Release Notes for the Cisco 575 LRE CPE

July 2001

This document provides corrections to the *Cisco 575 LRE CPE Hardware Installation Guide* and includes new information about connecting a telephone to the CPE. Use this document with the *Cisco 575 LRE CPE Hardware Installation Guide*.

Figure 1 Wall Jack to Telephone Connection

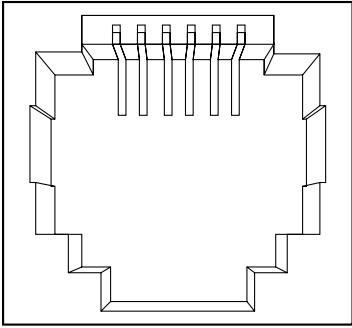
The “Installation” chapter of the *Cisco 575 LRE CPE Hardware Installation Guide* describes connecting the CPE WALL port to a telephone wall jack by using a standard RJ-11 telephone cable. We recommend using a telephone cable that has a three-pair, rollover configuration. [CSCdu55940]

To connect the CPE PHONE port to your telephone, use the telephone cable supplied with your telephone. (See [Figure 1](#).)

Figure 2 Correct CPE WALL Port Connector Pinouts

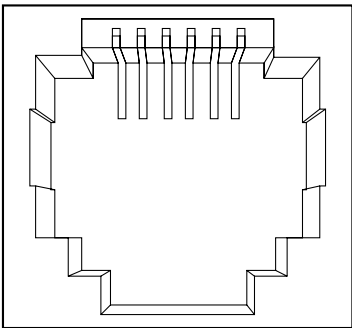
Figure B-3 and Figure B-4 in the “Cables and Connectors” appendix of the *Cisco 575 LRE CPE Hardware Installation Guide* incorrectly describe the CPE pinouts for the WALL and PHONE ports. [Figure 2](#) and [Figure 3](#) show the correct pinouts. [CSCdu55948]

Figure 2 pinouts are correct when you use a rollover cable between the wall jack and the CPE WALL port. For a complete list of pinouts between the wall jack and CPE, see [Table 1](#).
